Land to the East of Longwater Road, Finchampstead

Transport Technical Note 1

Rev B

1.0 INTRODUCTION

JOB TITLE Finchampstead			CLIENT Catesby Strategic Land Ltd	
DRAWING TITLE Proposed Site Access & Visibility Splays				
SCALE 1:500@A3	DRAWN BY DN	DATE Sept 24	DRAWING No 19200-01	REVISION F

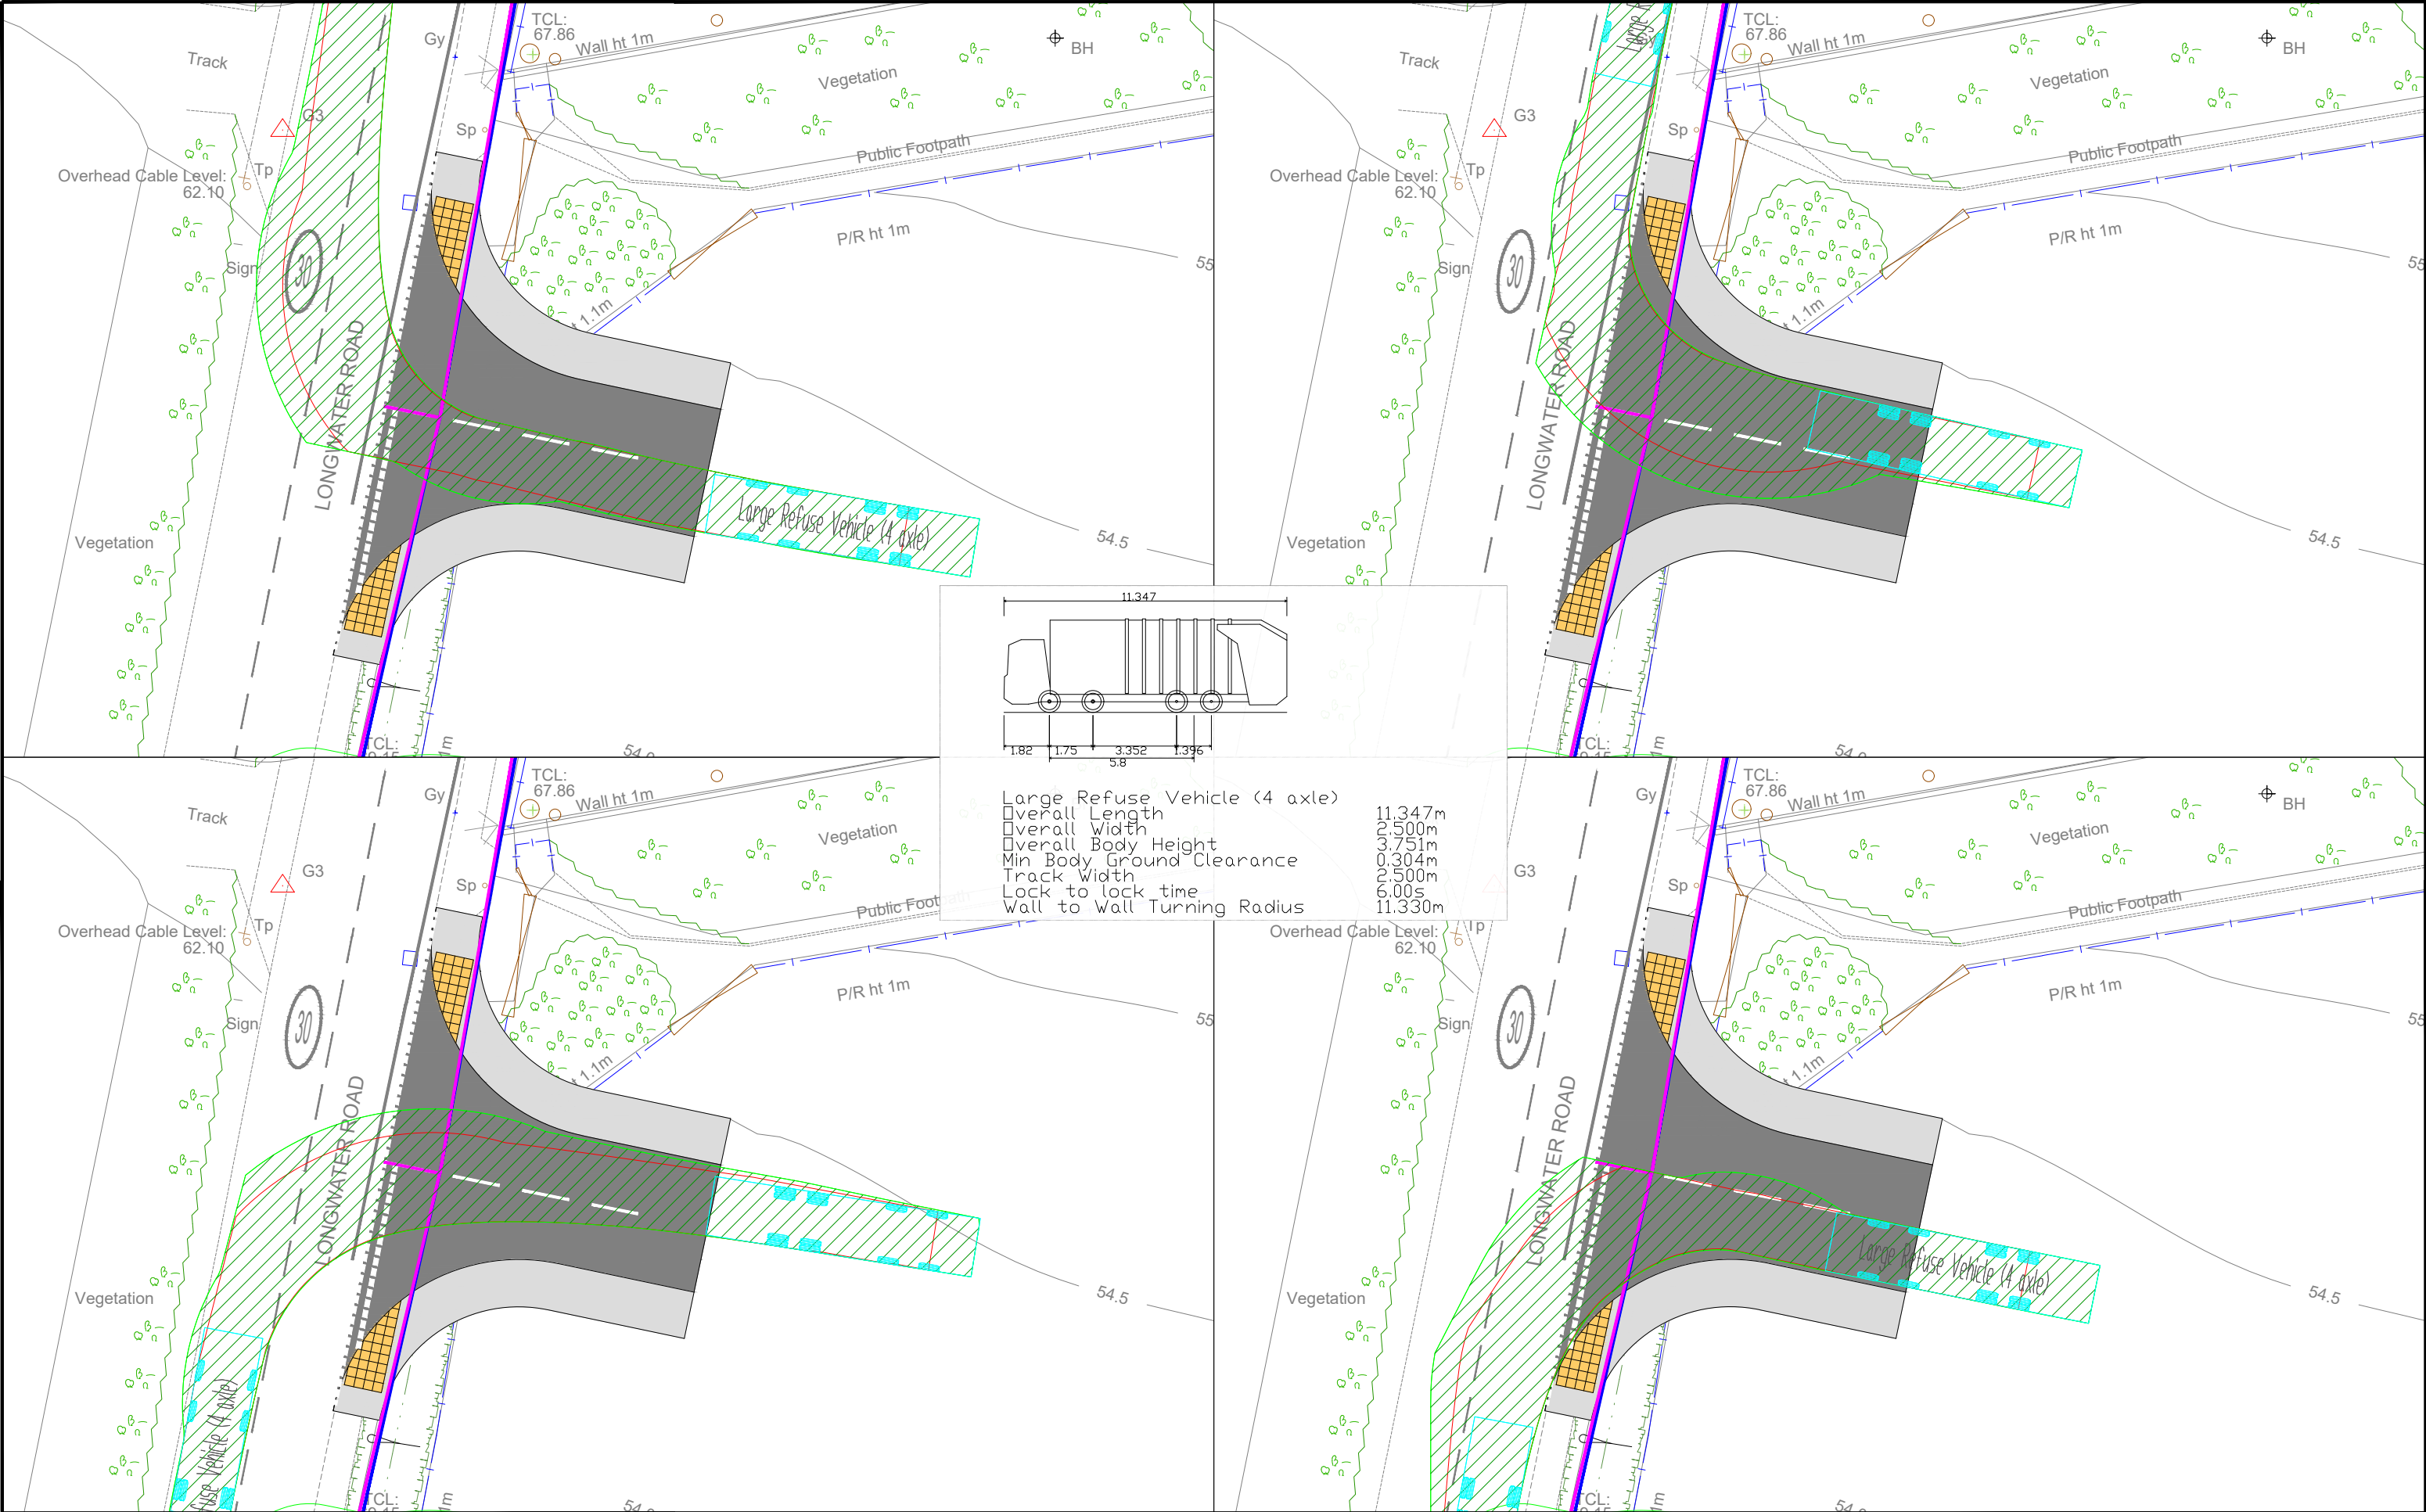
19. It is welcome that visibility splays for this proposed access have been design to actual 85th percentile speeds. The lengths of the splays have been calculated using the equation that is contained within MfS which is welcome. These calculations would need to be submitted.

20. Any landscaping within the visibility splay would need to be maintained to less than 0.6m in height. This would involve the removal and/or maintenance of more hedgerow.

2.4.4 DTA Response: To derive the necessary splays the 85th percentile speeds have been used. Therefore, as shown above, the average 85th percentile northbound speed of 41.4mph and southbound speed of 44mph have been used.

2.4.11 Therefore, using the rates set out above, results in an SSD of 118m.

2.4.12 These distances are presented on the site access drawing **19200-01 Rev F**.

- 2.4.13 DTA Response: It is expected that there will be a condition attached to any future planning consent requiring the visibility splays to be retained in perpetuity. The submitted landscaping strategy intends for the area within the visibility splay to be kept as grass.

Project	Land at Longwater Road, Finchampstead		
Drawing	Site Layout		
Client	Catesby Estates PLC & Stonebond Properties (Guildford) Limited		
Job no.	CATE230603	Date	26.03.24
Dwg no.	SL01	Rev.	B
Author	MK	Checked	
Status	PLANNING	Scale	1:500 at A1
Client ref.		Office	Romsey

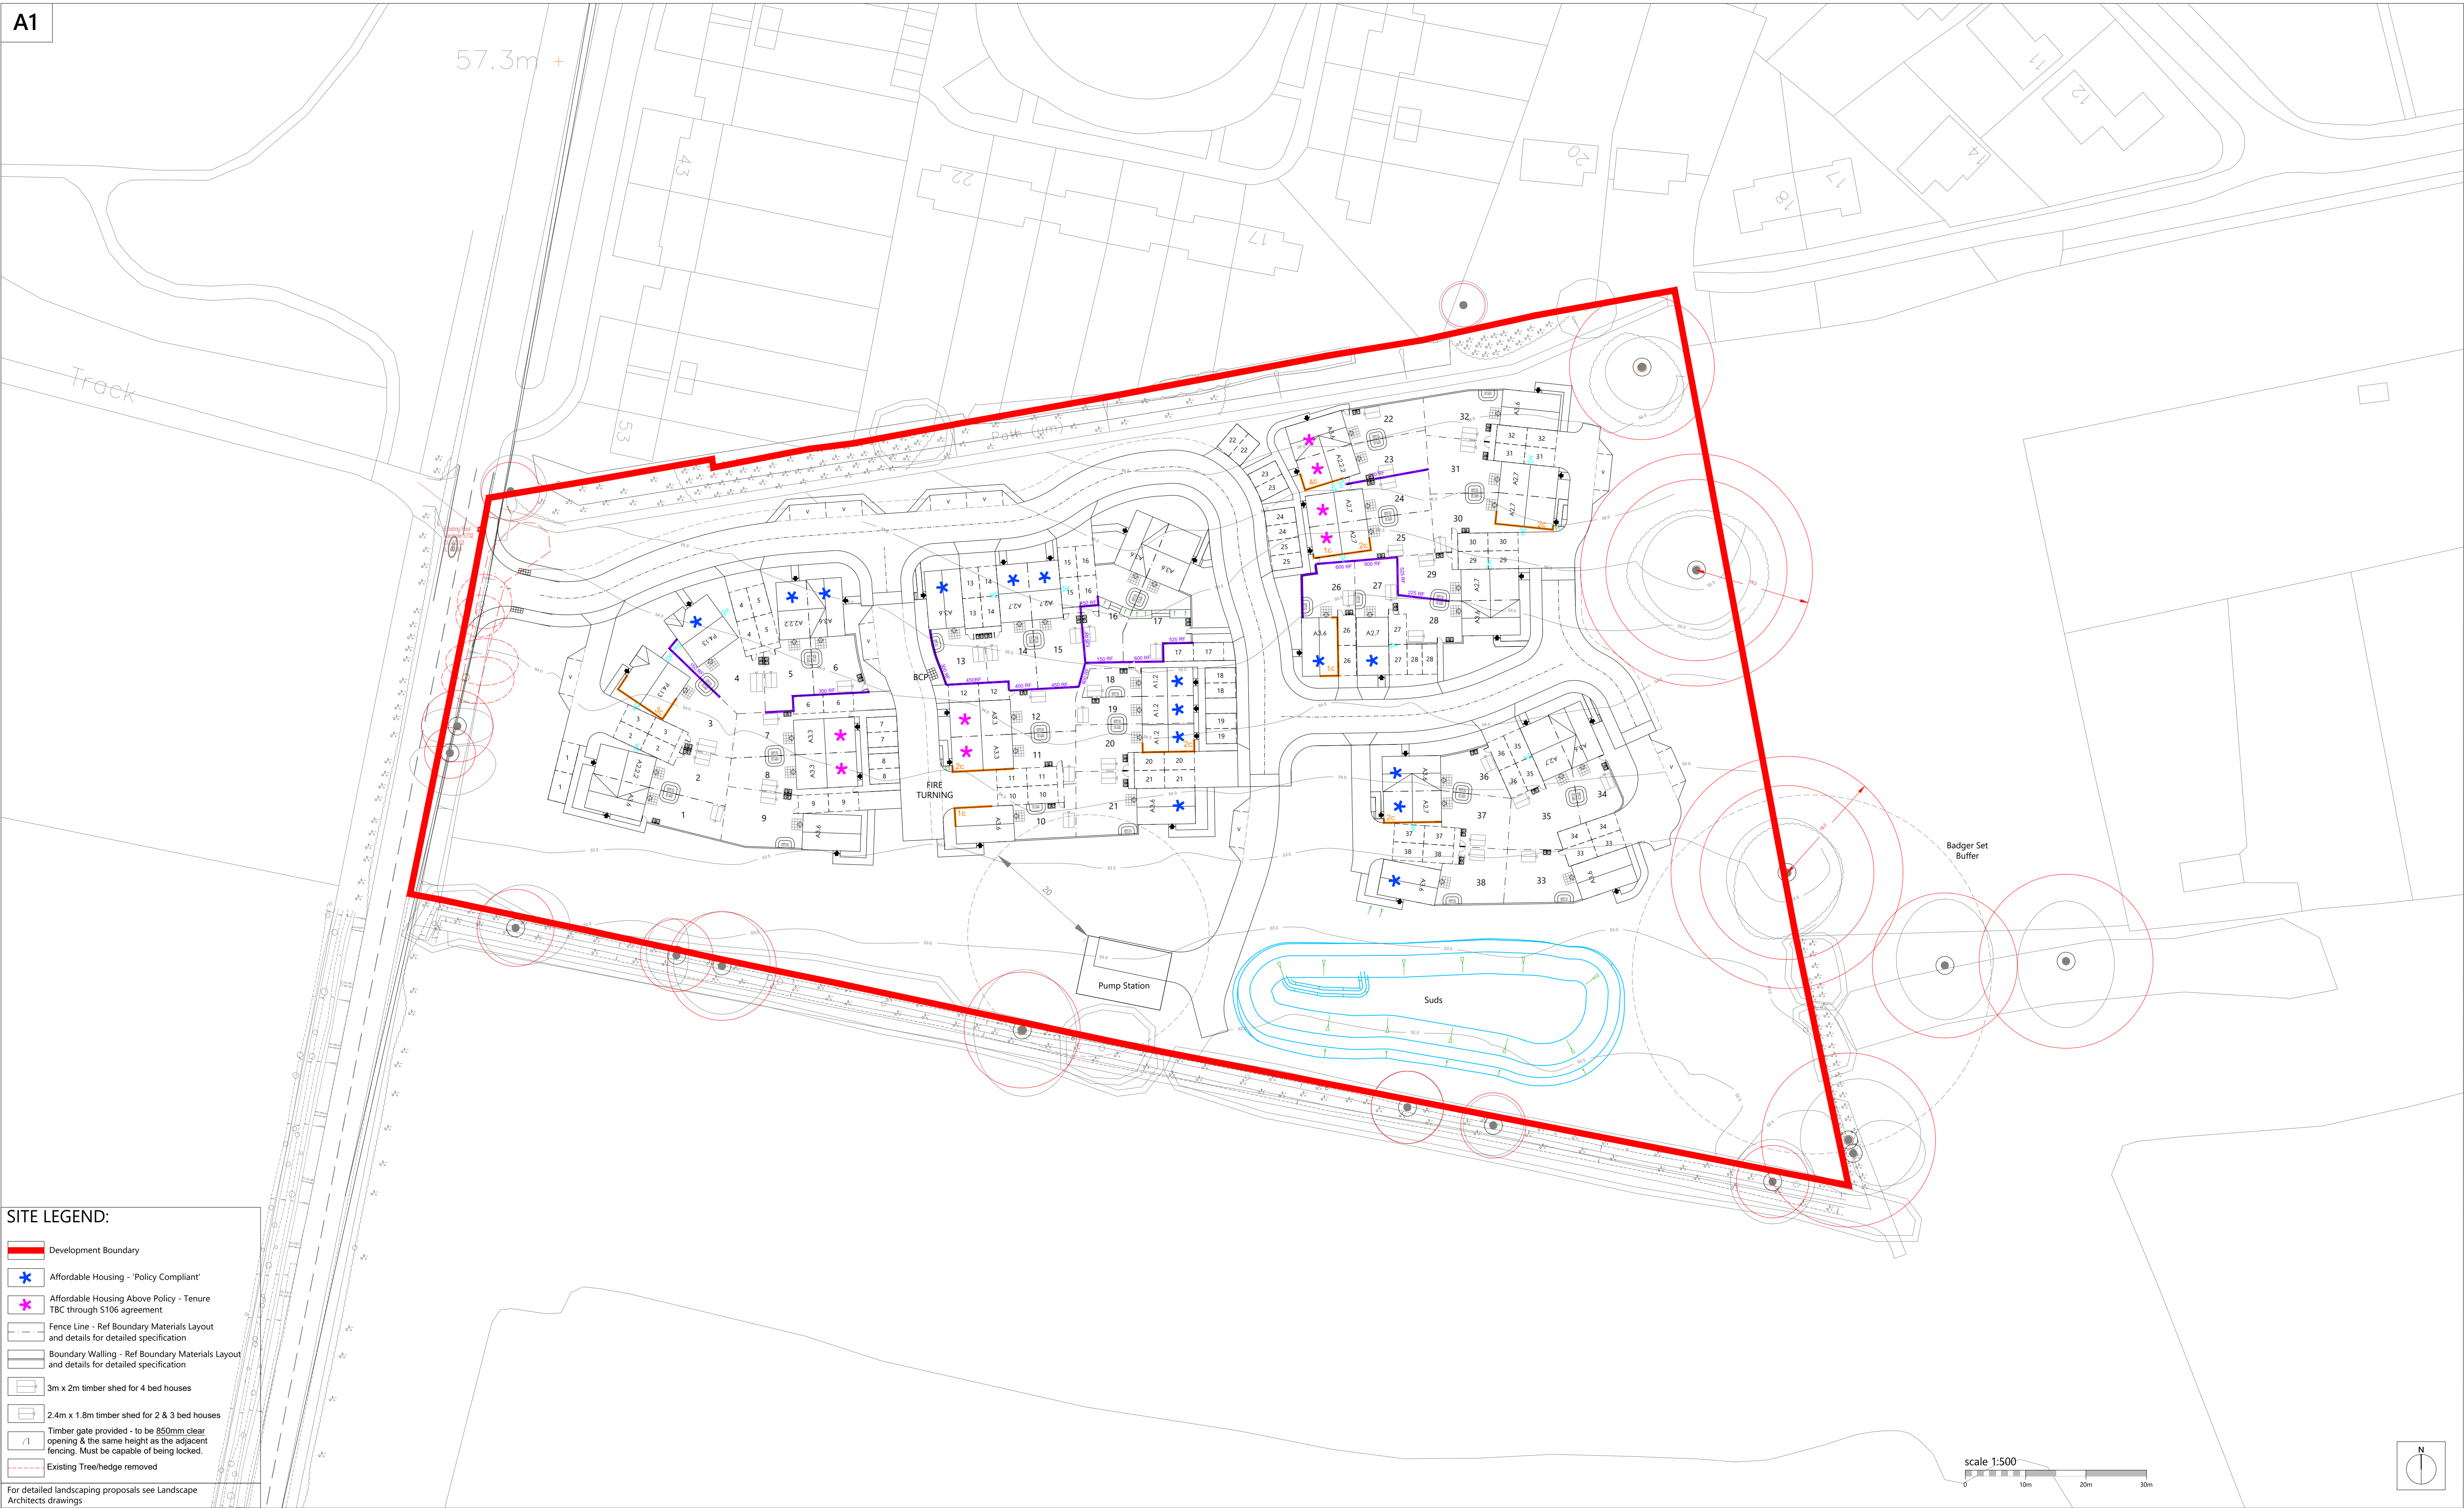
5. Parking Plan (PP01 Rev) shows all the allocated and visitor spaces but requires showing the 3 unallocated spaces.

6. In addition, there needs to be a better distribution of visitor spaces as there are none in the eastern section of this development.

8. The width of the single drives would need to be a minimum of 3.1m. The drive for plot 21 needs to be widened.

9. For plots 1 and 2, highways would recommend that the parking for plot 1 be moved to the west of plot 1 rather than where it is proposed.

10. Highways is also concerned with the design of the area set out below. There is insufficient turning space for the parking for plots 26 and 29 to manoeuvre safely. Indeed parking for plot 29 would need to be moved closer to plot 29.

11. It is welcome that cycle parking will be provided to Borough standards with on plot provision. These would need to be in rear gardens with direct access. Both the location and the direct access would need to be shown on a plan and submitted.

2.1.1 DTA Response: The layout has been updated to reflect the requirements.

2.1.2 DTA Response: Visitor parking has now been added to the east of the site.

2.1.3 DTA Response: The layout has undergone significant alterations therefore, all matters should now be addressed.

2.2.1 DTA Response: A drawing (SL01) showing these are submitted with the application, however, for ease of reference it is appended to this note.

Appendix 2 – Problem Location Plan

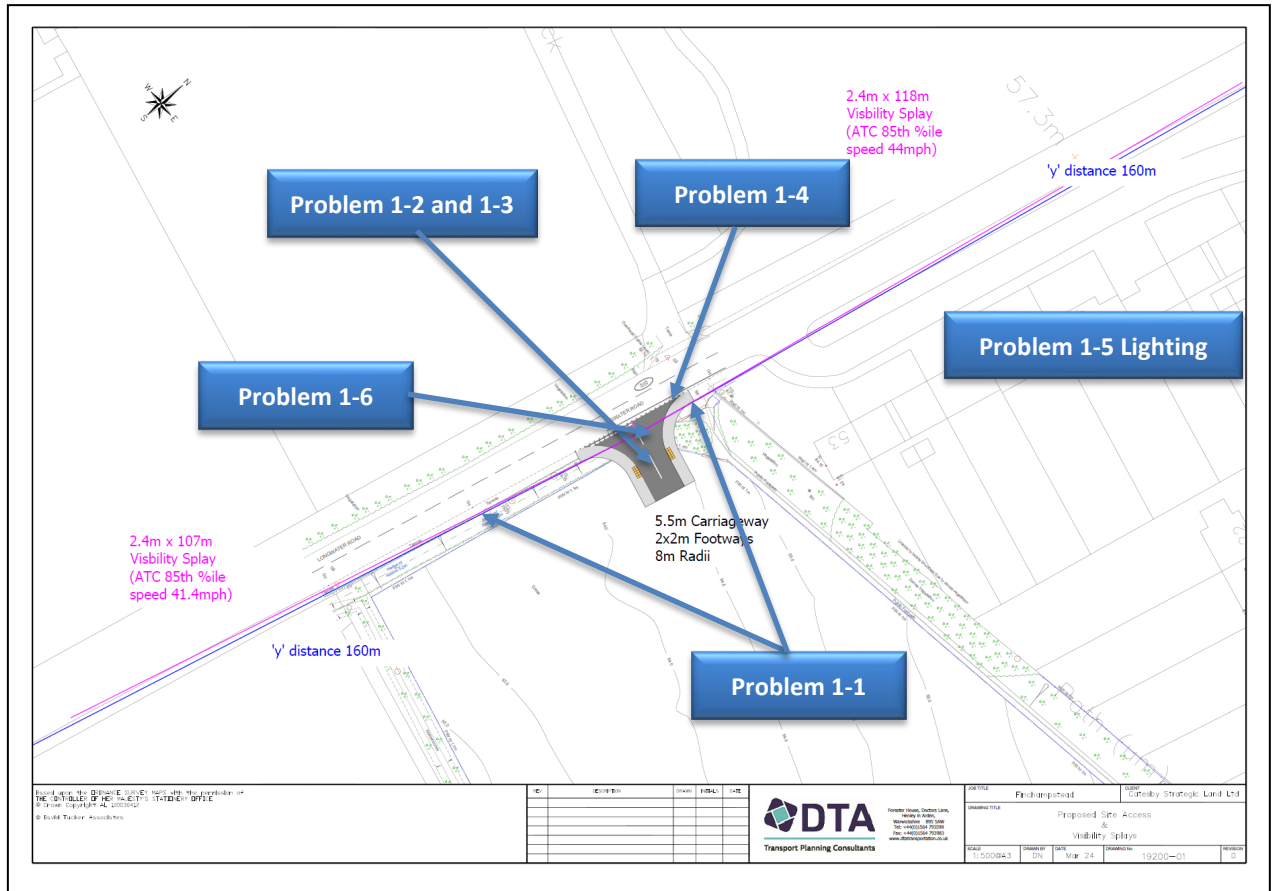
PROBLEM		1-4
Location:	Site access.	
Summary:	Manhole covers where vehicles are turning will increase the risk of loss of control type collisions.	
It is proposed to construct a new site access junction onto Longwater Road. There is an existing manhole within the carriageway, and this will be within the area where vehicles (especially cycles and powered two wheelers) are turning left into the development. There is a serious risk that this will result in loss of control type collisions.		
RECOMMENDATION		
Either move the manhole into the footway/verge or replace the cover with one that is skid resistant.

PROBLEM		1-6
Location:	Longwater Road/Site Access.	
Summary:	Signing inappropriately located will increase the risk of collisions.	
It is proposed to construct a new development access this is currently where there is a change in speed limit 60/30. These signs will need to be moved away the junction. Signage inappropriately located will increase the risk of collisions.		
RECOMMENDATION		
As the signs will need to be moved to accommodate the new access it is recommended that these are also moved further to the south away from the access junction which will help to further reduce speeds in advance of the access.

PROBLEM		1-7
Location:	Internal roads.	
Summary:	A lack of suitable safe crossings locations will increase the risk of pedestrian/vehicle collisions.	
The drawing provided of the new internal road layout associated with the development does not show any uncontrolled crossings of the internal road layout. A lack of suitable safe crossings locations will increase the risk of pedestrian-vehicle collisions.		
RECOMMENDATION		
Provide uncontrolled crossings within the internal road layout.

Problem: 1-4 Location: Site access Summary: Manhole covers where vehicles are turning will increase the risk of loss of control type collisions.. It is proposed to construct a new site access junction onto Longwater Road. There is an existing manhole within the carriageway, and this will be within the area where vehicles (especially cycles and powered two wheelers) are turning left into the development. There is a serious risk that this will result in loss of control type collisions.	Either move the manhole into the footway/verge or replace the cover with one that is skid resistant.	The problem and recommendation are accepted. As part of the technical approval process for the S278 works, the final arrangement of either relocating the manhole or replacing the cover will be agreed with the Highway Authority.		
--	---	---	--	--

Problem: 1-6 Location: Longwater Road/Site Access. Summary: Signing inappropriately located will increase the risk of collisions. It is proposed to construct a new development access this is currently where there is a change in speed limit 60/30. These signs will need to be moved away the junction. Signage inappropriately located will increase the risk of collisions.	As the signs will need to be moved to accommodate the new access it is recommended that these are also moved further to the south away from the access junction which will help to further reduce speeds in advance of the access.	The problem and recommendation are accepted. It is proposed to extend the 30mph limit to the south to fully incorporate the site access. The associated signage will be relocated.		
--	---	---	--	--

Problem: 1-7 Location: Internal Roads. Summary: A lack of suitable safe crossings locations will increase the risk of pedestrian/vehicle collisions. The drawing provided of the new internal road layout associated with the development does not show any uncontrolled crossings of the internal road layout. A lack of suitable safe crossings locations will increase the risk of pedestrian-vehicle collisions.	Provide uncontrolled crossings within the internal road layout.	The problem and recommendation are accepted. The detail and location of all dropped crossings (with and without tactile paving) will be set out and agreed with WBC during the detailed design process of the internal layout as part of the S38 approval.		
--	--	--	--	--
